Statement of persons granted permission to build.

— AMENDED —
— PLAN OF PROPOSED ADDITION —
— ON PLOT N^o 29B-D-3 —
— TEHILRAM QR —
— SCALE 8"=1" —

With reference to ^{his} _{their} application dated 13th December 1925 with aplan for the proposal ^{Building} _{additional} on plot No. 293 Survey Sheet No. 8-3

With reference to ^{his}~~their~~ application dated...4th November 25... with a plan for the proposed ^{Building}~~additional~~ on plot No. 29.B... Survey Sheet No. D3... Tahelraun... Quarter Mr. Kare Virchand... is informed that until the following requirements are complied with the plans cannot be passed.

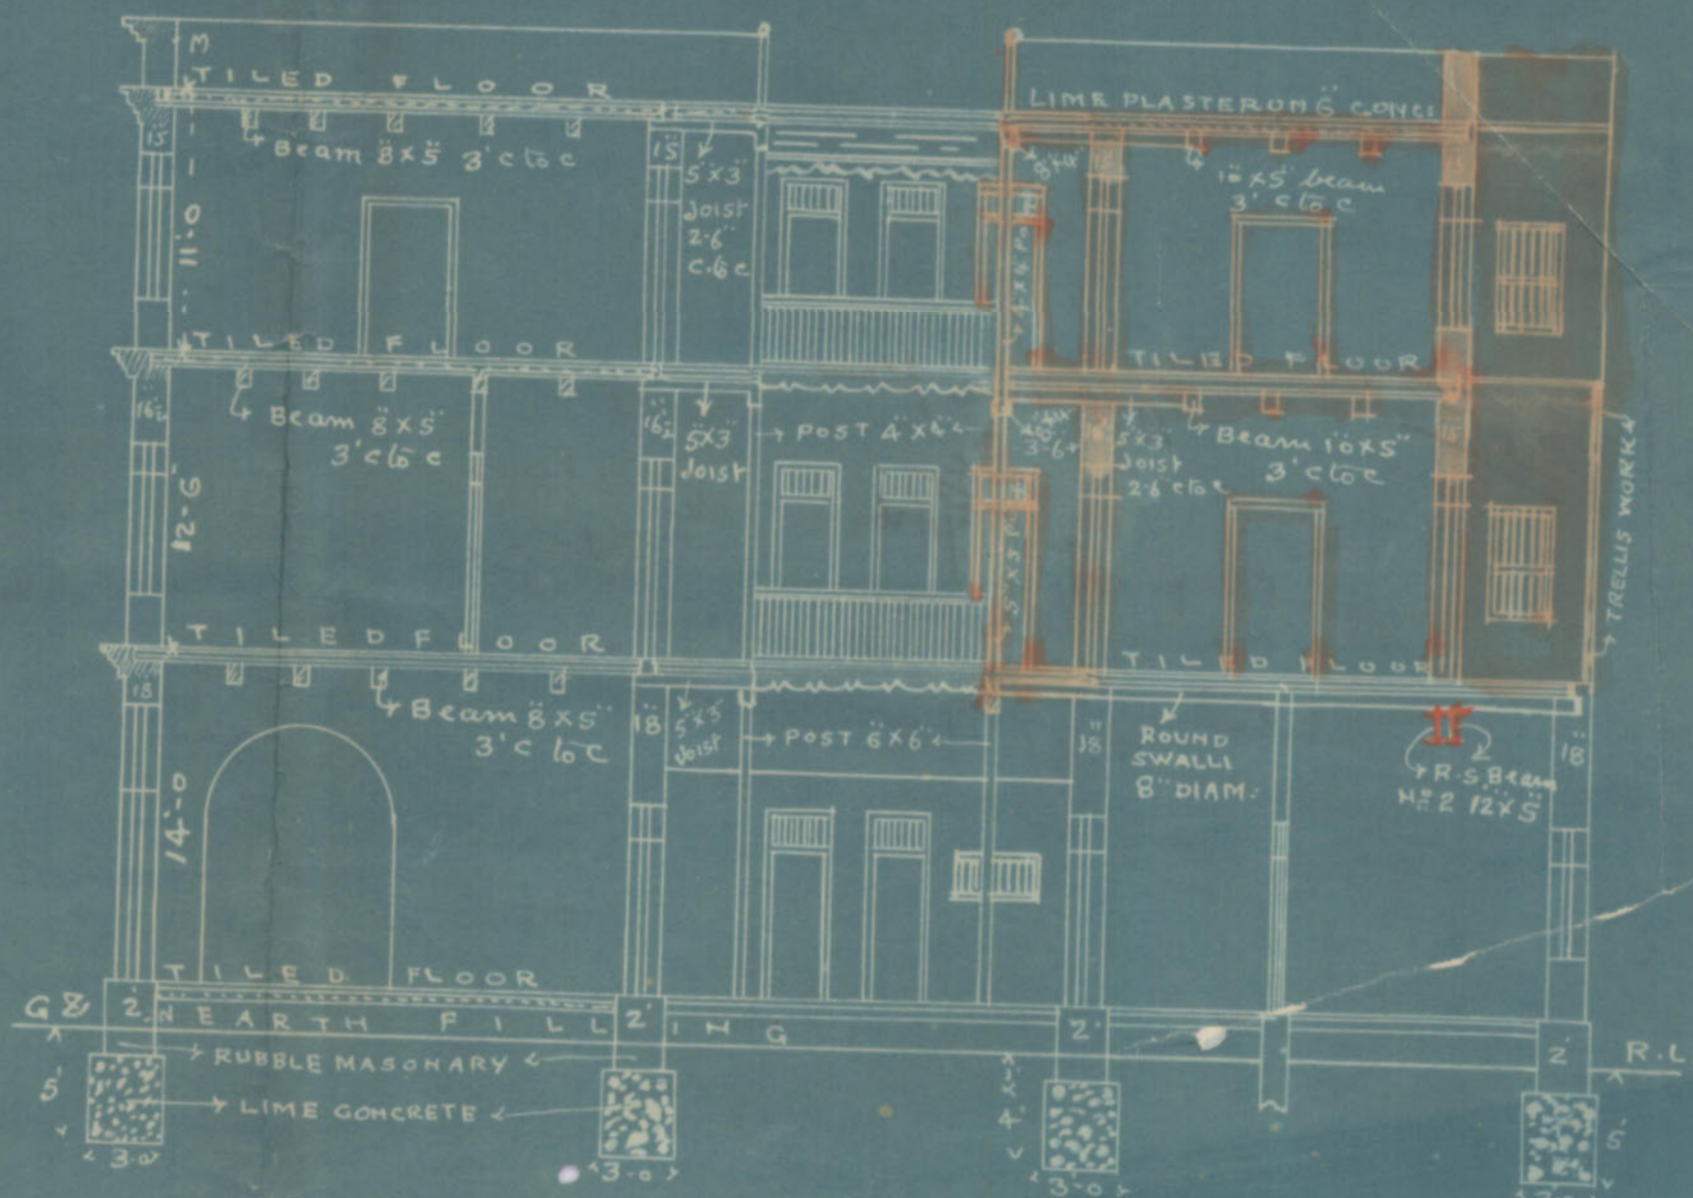
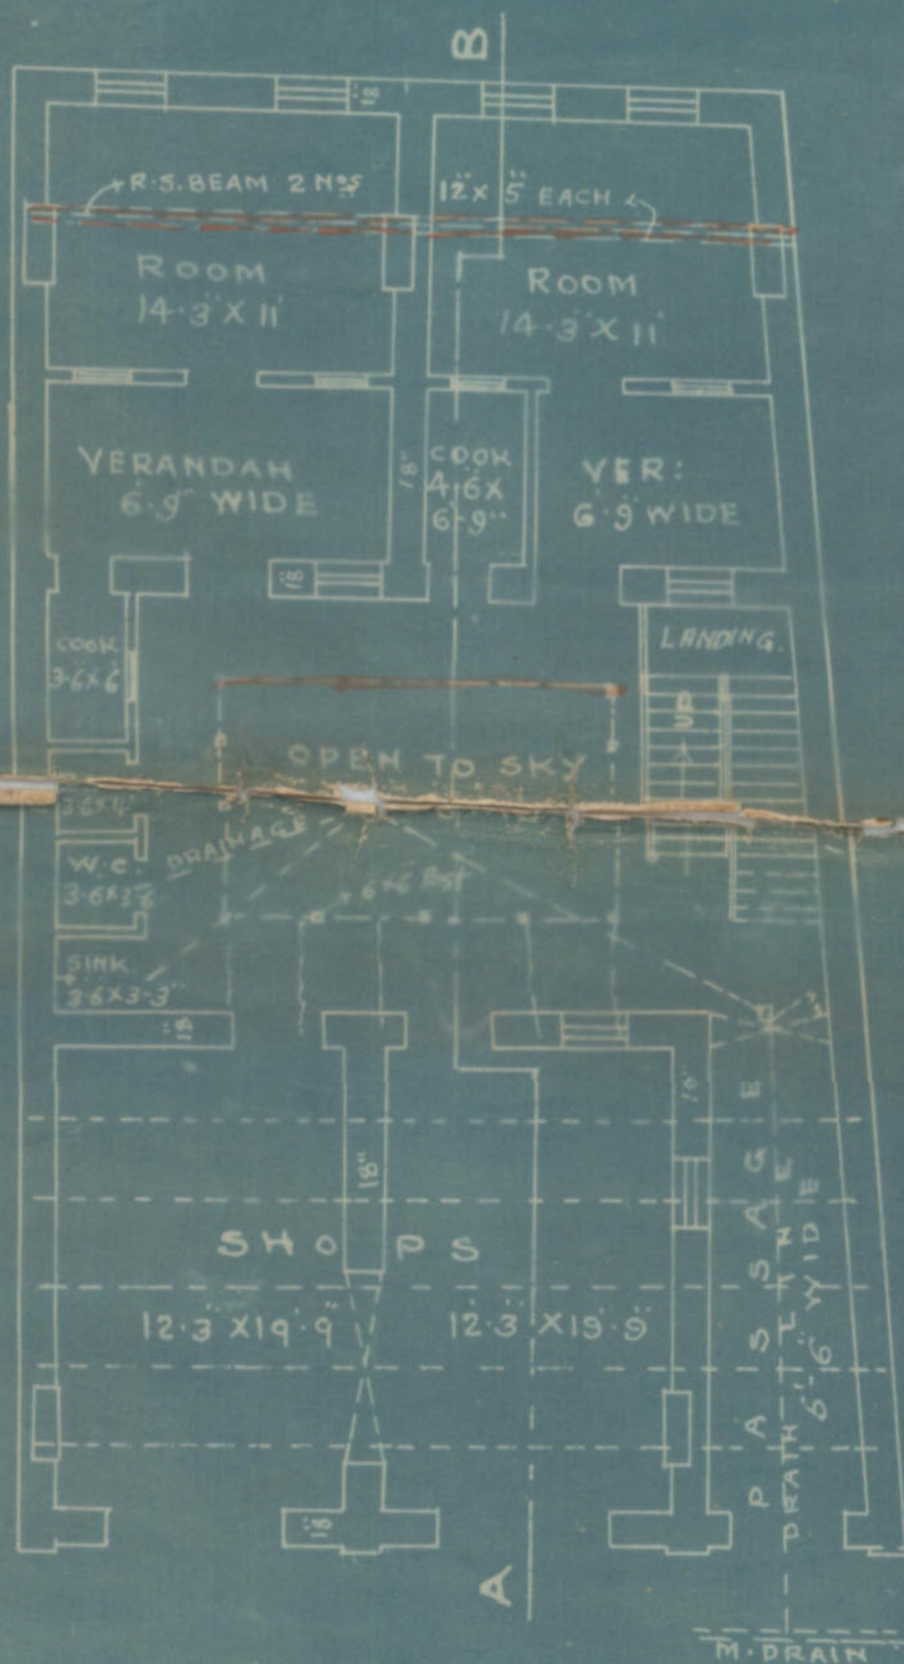
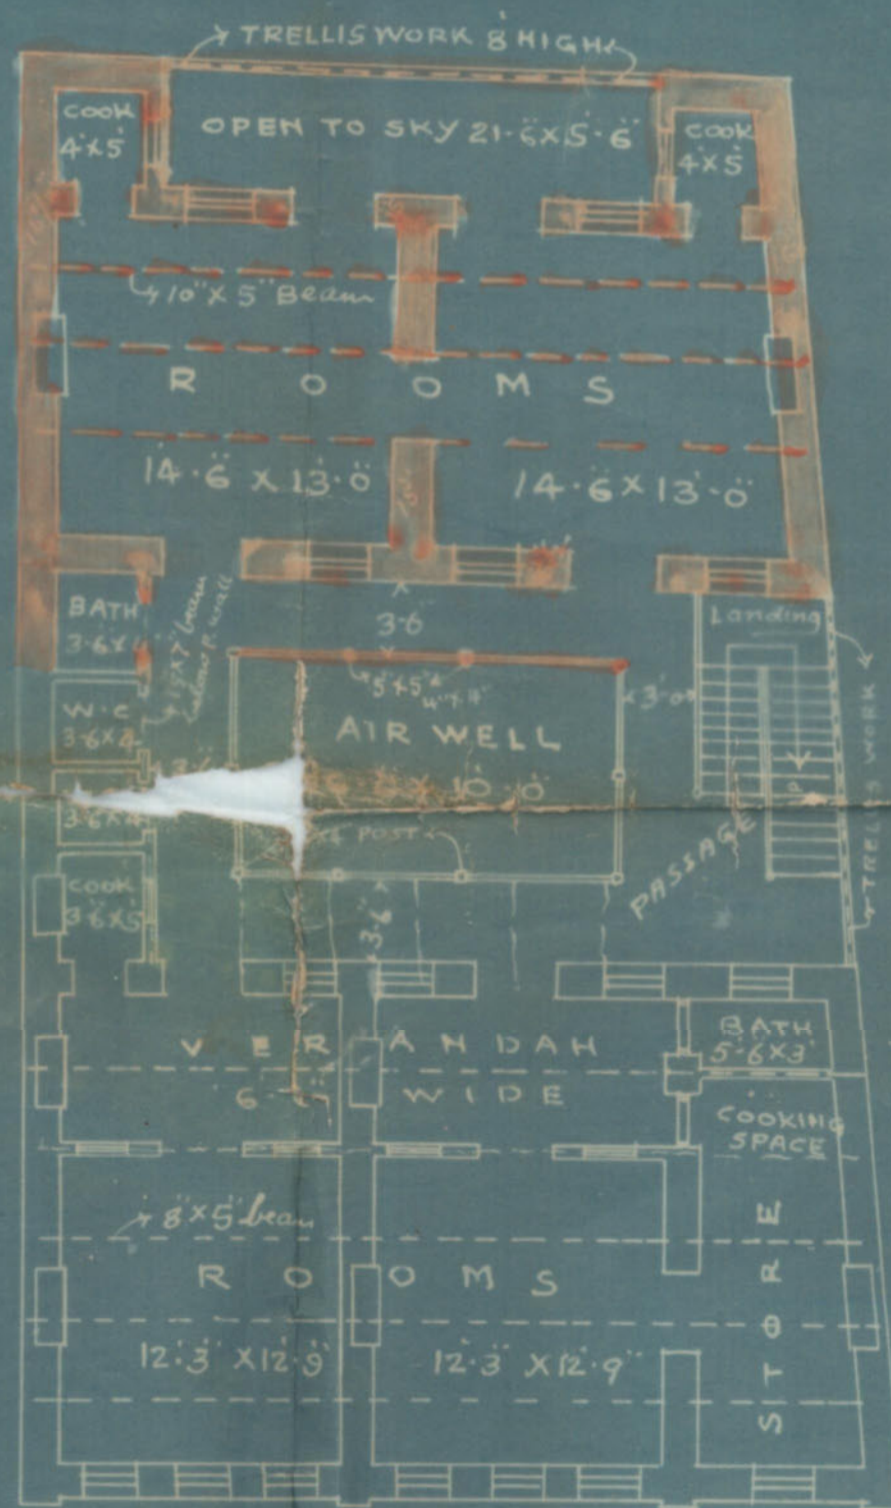
- (1) Sir,
- (2) There is no objection to the
- (3) Amended plan as the ventilation
- (4) of the rooms is made "through"
- (5) ventilation and there are no
- (6) corridors kept open at back. The
- (7) plans may now be passed. Sizes of
- (8) beams are sufficient.
- (9) C. E. Parker

With reference to your letter No.L.M.A. 12346 dated 21st December 1925, I beg to submit herewith four copies of amended plans of proposed additional floors on plot No. 29.B., sheet D-3 Tahilramquarter for favour of early approval.

— PLAN OF PROPOSED ADDITION —
— ON PLOT-N: 29B-D-3 —
— TEHILRAM QR —
— SCALE 8=1 —

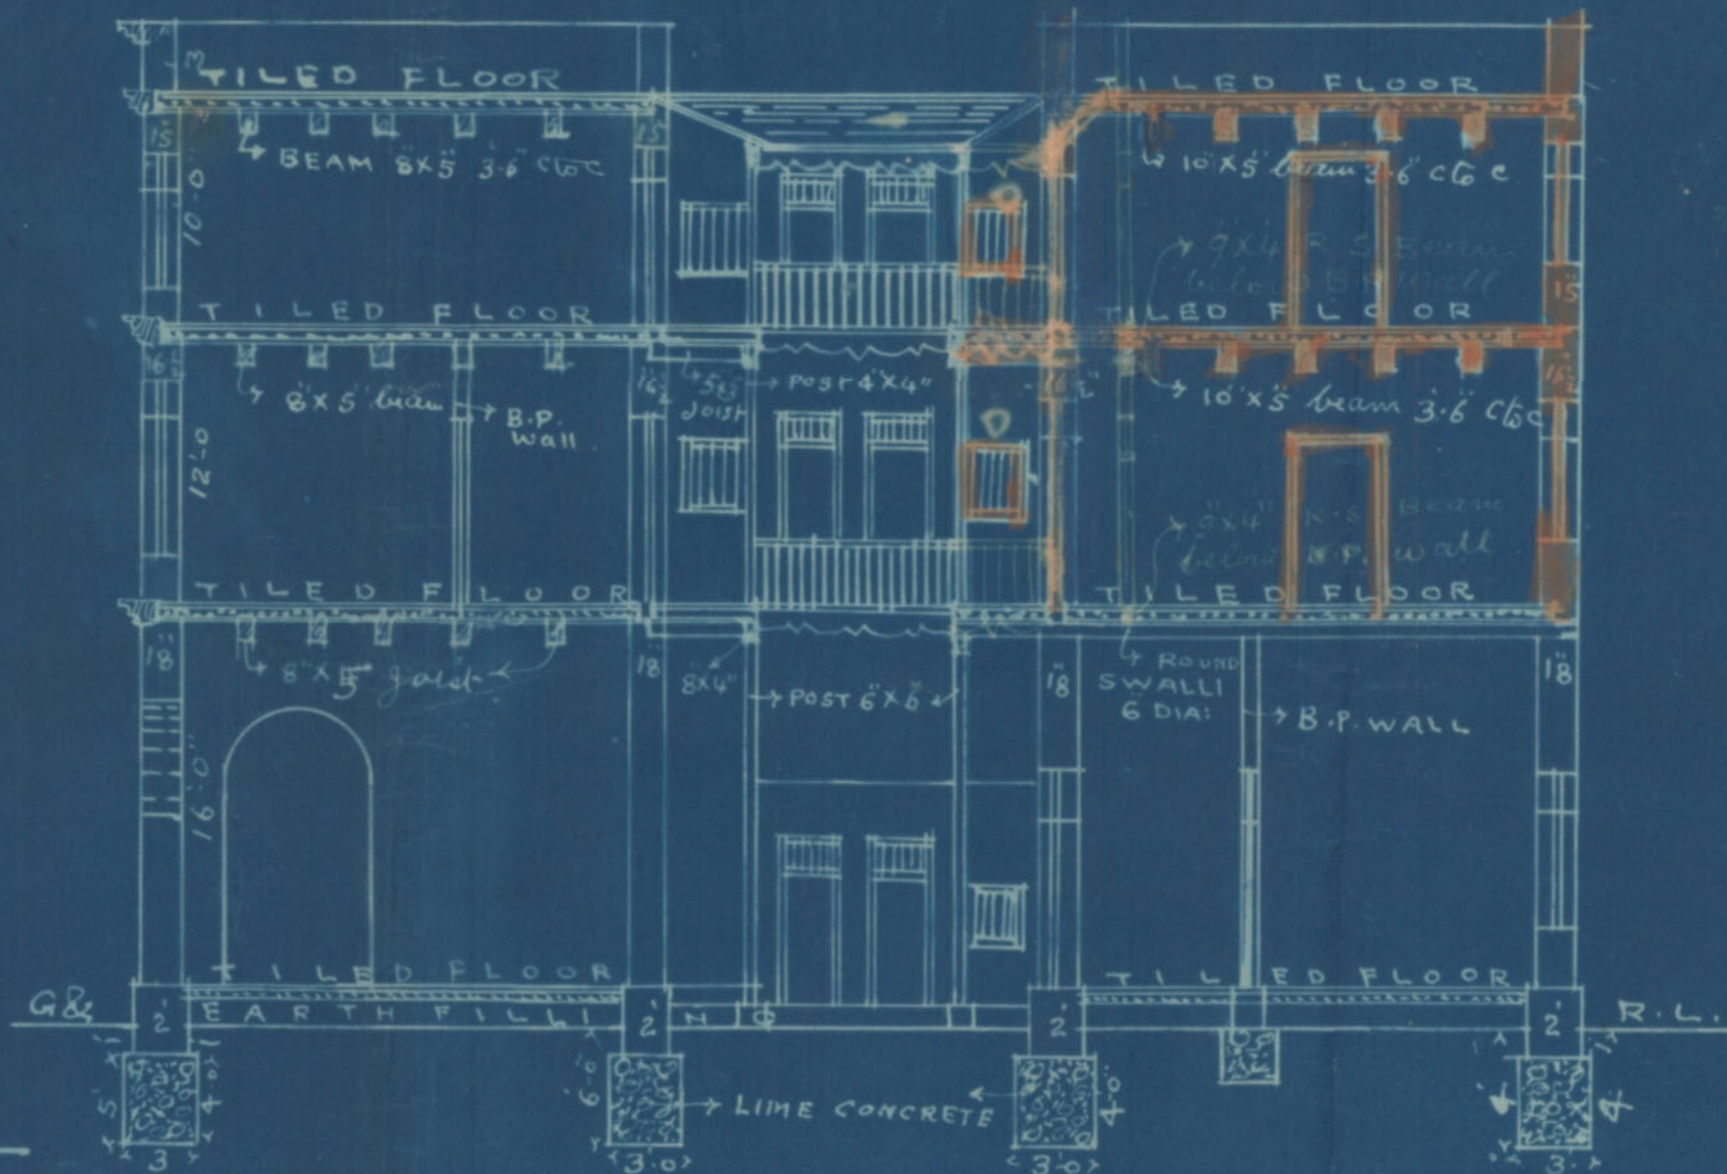
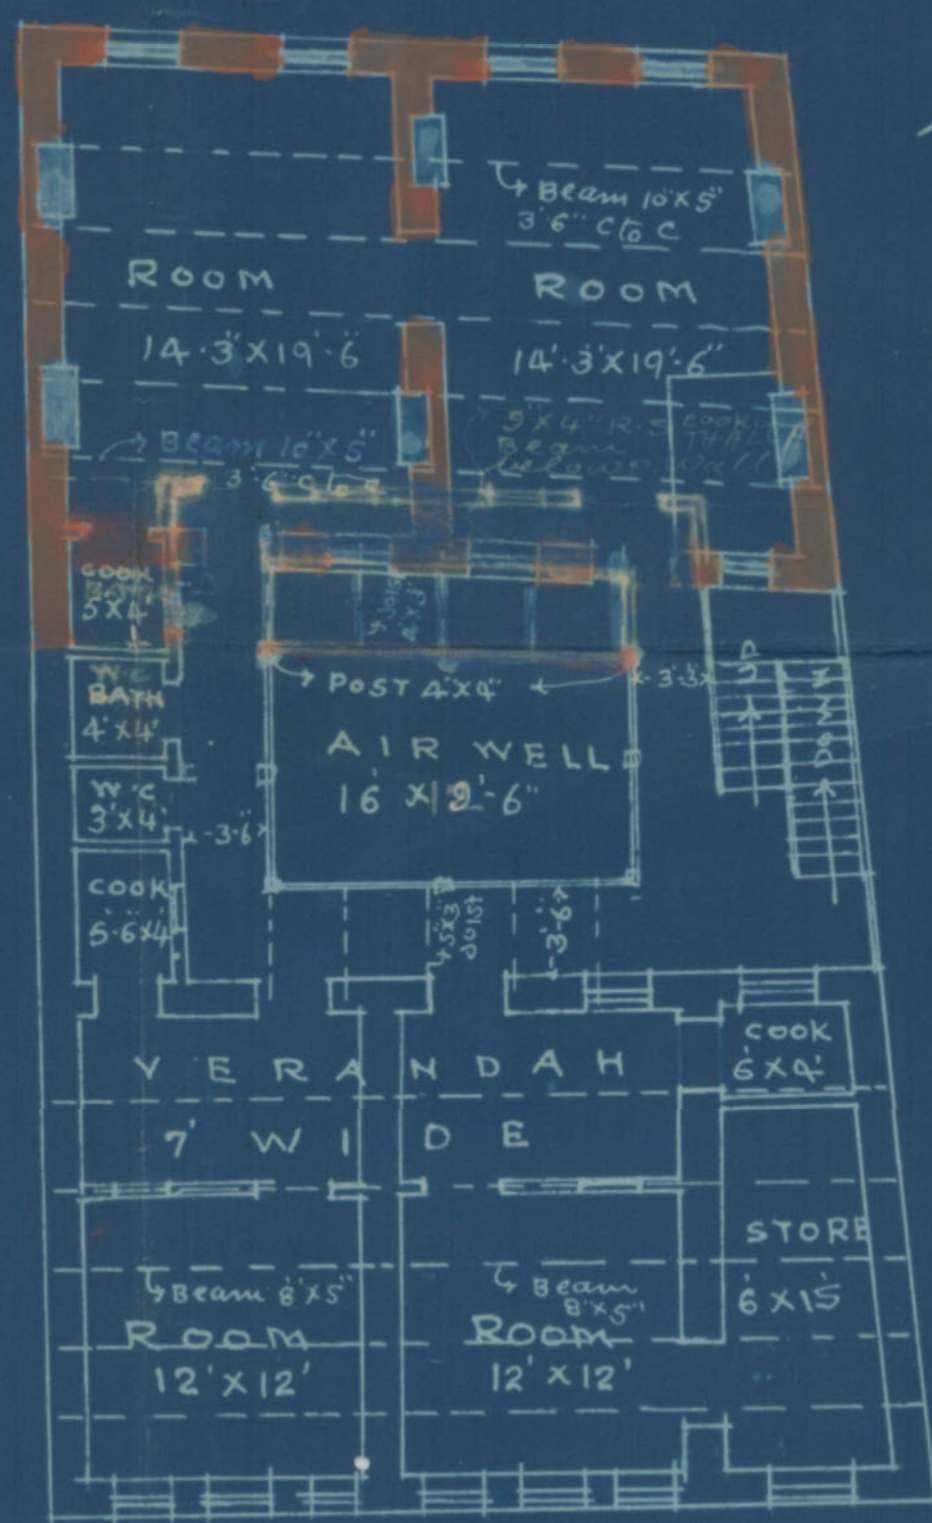
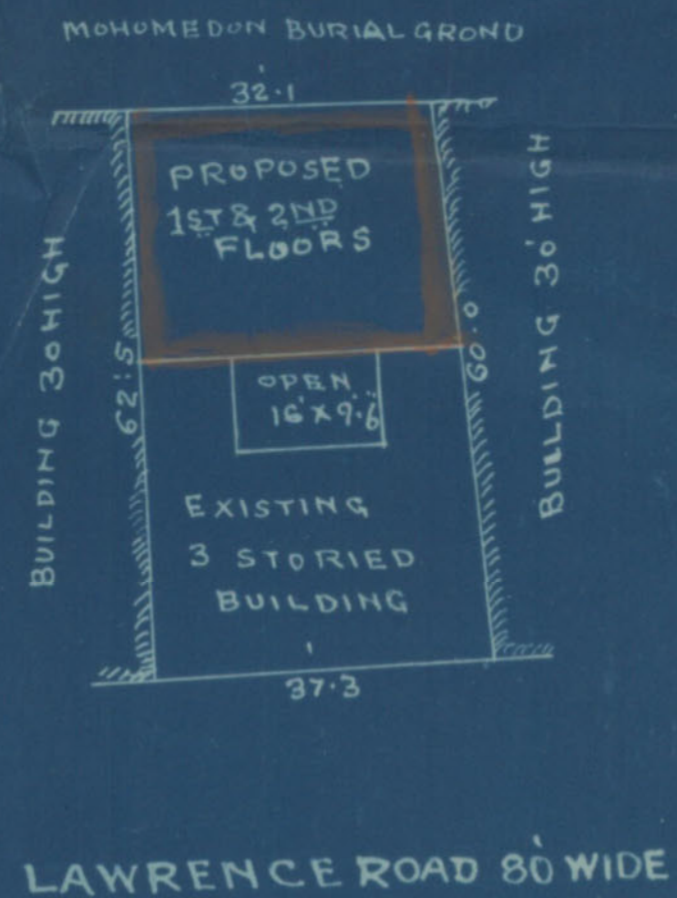
- (1) Air wall should extend right up to the North East wall
- (2) Permission of the Trustees of the Burial Ground to open windows is necessary
- (3) Exterior wall of the rooms on 1st & 2nd floor must be pucca fronting the open space & walls. Say 15" R.C.
- (4) Beams underneath is too weak.
- (5)
- (6)
- (7)
- (8)
- (9)

1/1/1
① air well should extend
right up to the North end
wall

② Perimeter of the Transept
of the Basilica ground is
the window is
necessary.

③ Ext. wall of the
room at the flow
from the other walls
must be built
A full ~~carried~~ R.C. beam
15" in dia
weak.

The beam under partition wall must be 12" x 6"
Posts on first floor must be 8" x 5"
The owner's statement re opening of windows at the back is correct.

Sir,
With reference to your letter No. L.M.A. 11486 dated 25th November 1925, regarding proposed additional floors on plot No. 29 B, Sheet D-3, Tahilram Quarter, I beg to submit herewith four copies of plans duly provided more air well as desired.

Regarding windows opened on burial ground, I beg to state that these windows are already opened on ground floors as well as first and second floors by all the adjoining plots on the same side as there is duly compound enclosers but not a private owner nor any plots number. So permission cannot be taken from anybody as this is a old burial ground closed. But if anybody will raise objection in future, I agree to close these windows, subject to the above kindly approve my plans at your earliest convenient.
